Response to OCB Board question regarding the extent to which the proposed FRE Project would be able to regulate the 100-year flood scenario under projected climate change conditions

Chehalis River Basin Flood Control Zone District

Figure 2 –Operating Protocol – 100-year Event with Climate Change
Source: WSE, 2021 data, obtained from Anchor routing analysis under future climate change conditions)

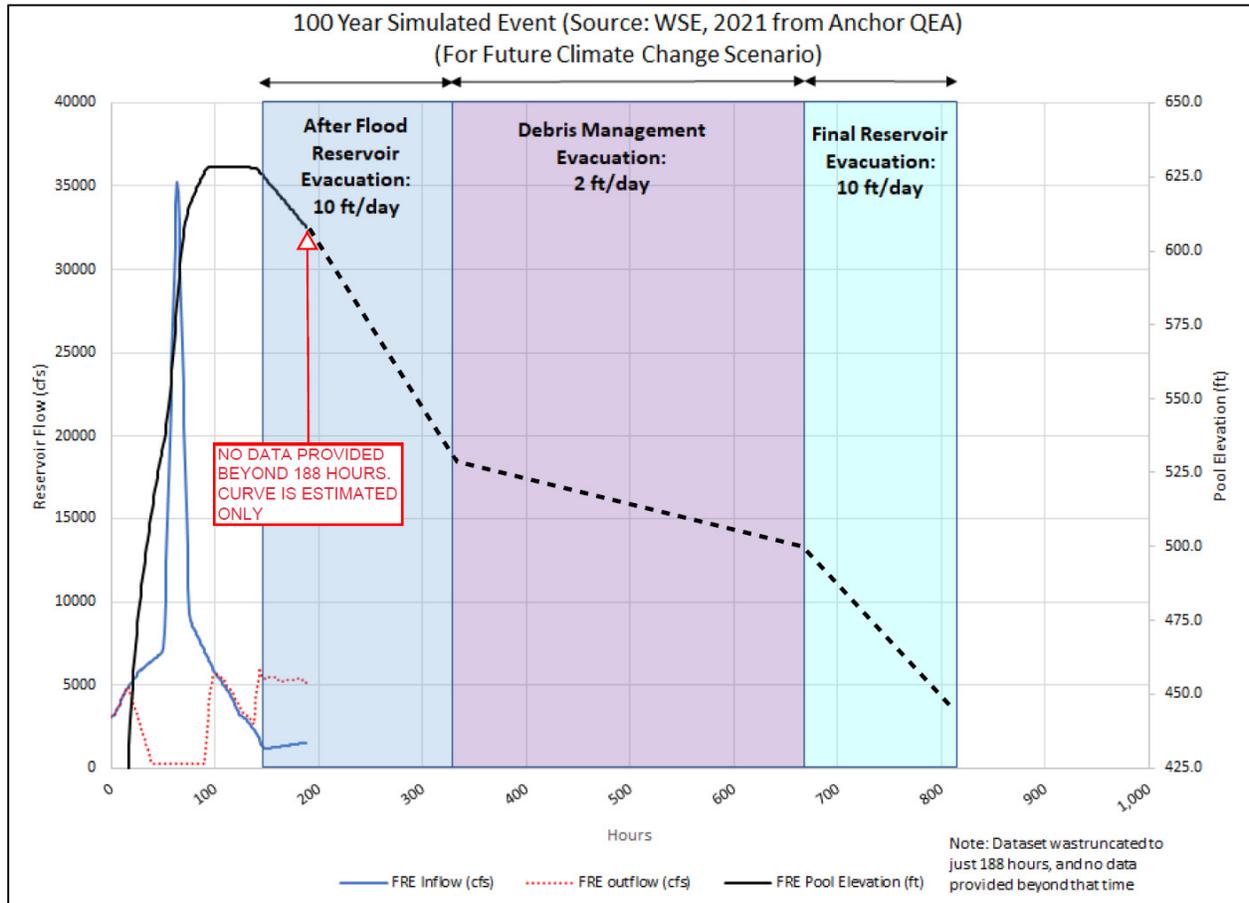
Under the Governor's directive to more extensively evaluate basin-wide flood damage reduction measures, the OCB Board has inquired about the ability of the proposed FRE to regulate projected 100-year flood flows at the increased flow levels projected under climate change conditions. At issue is the degree to which adequate flood damage reduction would still occur downstream of the FRE under climate change conditions.

Under climate change conditions peak inflows to the reservoir for a 100-year recurrence interval event could increase 26% – 50%. If the climate change projection should come to pass, a revised operating protocol would be developed to address flood regulation optimization across a range of different flood events. Depending on the relative peaks in inflow arising from the three major tributaries to the mainstem Chehalis River at, FRE operations may delay gate closure or allow more outflow during the peak of the event, if the travel time and combined peaks of the other two major tributaries would already have passed the downstream major damage area and the increased releases from the FRE facility would not reach the damage area until well after the peak from the uncontrolled tributaries had passed. Or, the gates could be closed as per the current plan and the reservoir would fill and then spill, with perhaps the timing of the spill also occurring after the peak downstream stage had been passed and the additional FRE outflow would backfill behind the downstream peak but not exacerbate flood stages. Overall, the operation of the FRE would likely strategically store and release flows from the FRE with the appropriate timing so as to not increase control flood levels in the affected area.

The future climate change anticipated peak inflow and maximum reservoir level that might be expected in future should the projected climate change scenario occur. This operational curve assumed the hydrograph increases 50% in volume compared to the current event, as projected. The curve reflects the 'fill-and-spill' scenario discussed above. Similar to the current operation plan, the outflows from the project would increase after the downstream peak was forecasted to pass, allowing the reservoir to be evacuated and cleared of debris. It should be noted that actual regulation of the reservoir during a flood event in which the FRE structure is activated will require hourly adjustments in gate operation and storage/outflows in response to the evolving inflow hydrograph and downstream flooding potential.
